SB-GA8-2009-53

Issue 6

Service Bulletin

Undercarriage Access Panel Retrofit

Figure 1: Rivets to be removed from belly (only the inside rows of rivets of the double rows shown).

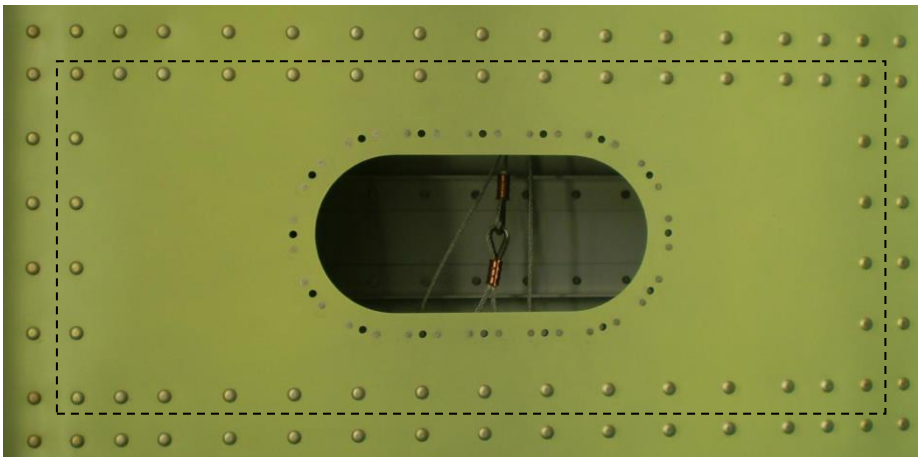
1. Jack aircraft as required.
2. Drill out and remove the domed head rivets within the dotted boundary shown in Figure 1 in the belly surrounding the existing undercarriage access panel.

Figure 2: Drill-off template detail.

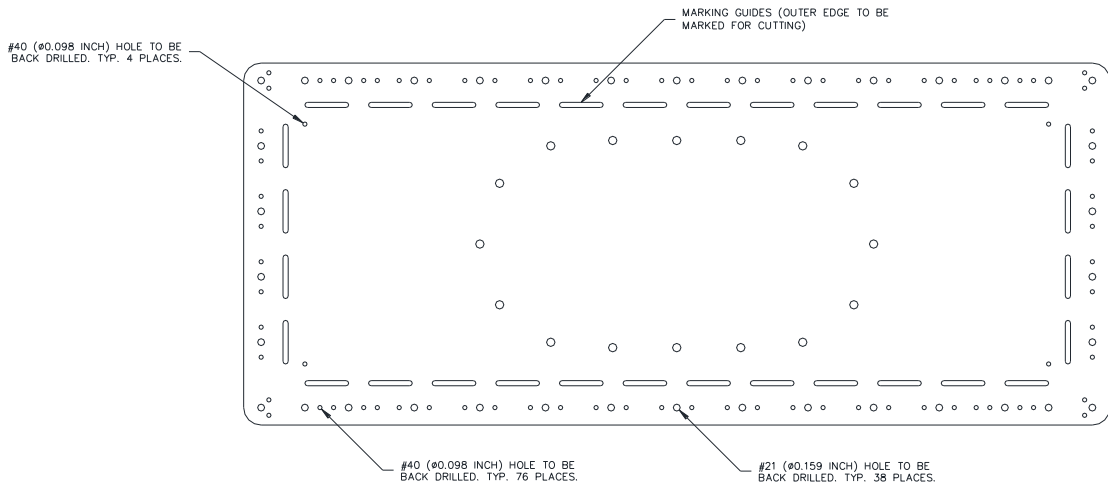
3. If the existing access panel is secured, unscrew and remove it.
4. Using the same screws for securing the existing access panel, secure drill-off template (P/N GA8-945321-021) to the belly in place of the existing access panel. Refer to Figure 2.

5. Drill the #21 (0.159 inch diameter) and #40 (0.098 inch diameter) anchor nut holes around the edge of the drill-off template, further securing the template as required by pinning it to the belly as holes are drilled.

6. Drill the four #40 (0.098 inch diameter) holes inside the corners of the marking guides of the drill-off template.
7. Mark the the new access hole using the marking guides in the drill-off template. The outside edges of the inch-long slots are the edges to be marked.

Figure 1: Hardware to be installed on belly skins

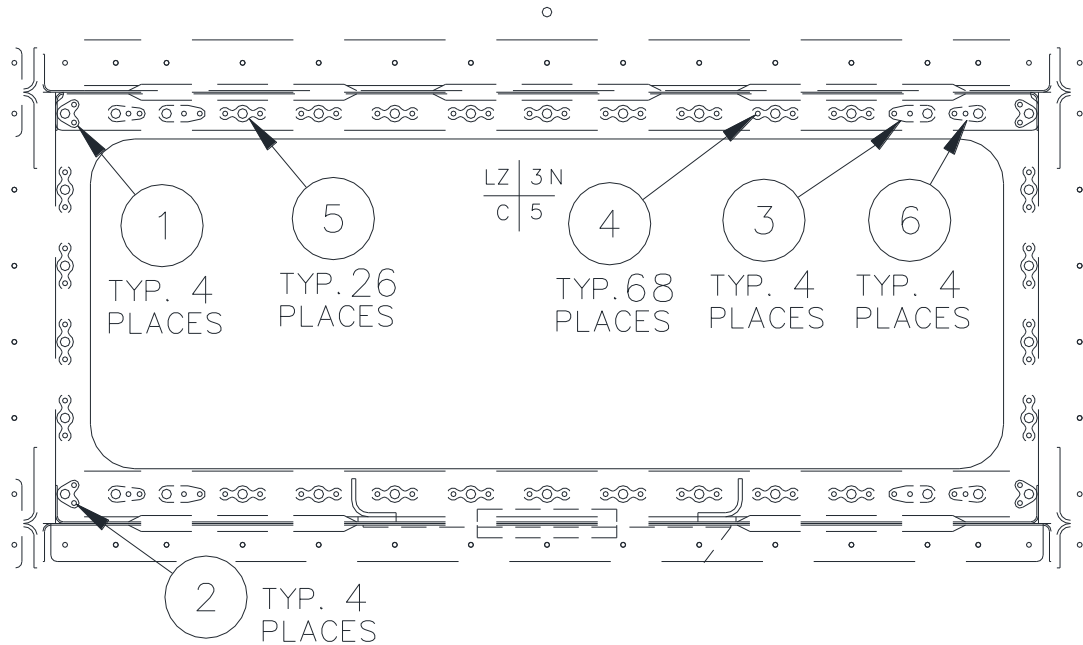
1. Jack aircraft as required.
2. Remove the existing mid cabin belly skin (P/N GA8-533021-25) and fwd cabin belly skin (P/N GA8-533021-13) surrounding the existing undercarriage access panel and replace it with GA8-533021-115 (mid cabin belly skin) and GA8-533021-113 (fwd cabin belly skin).

3. Install four MS21073L3 corner leg anchor nut in each corner using MS20426AD3-6 rivets.
4. Install four MS21051-L3 one leg anchor nuts inboard of each corner leg anchor nut using NAS1097AD3-5 rivets.
5. Install MS21047-L3 anchor nuts and MS21071-L3 one leg anchor nut in remaining locations using NAS1097AD3-5 rivets.
6. Install placard (P/N GA8-112011-401) onto the inside face of the new access panel (P/N GA8-533021-129).
7. Install the new access panel using AN525-10R8 screws.
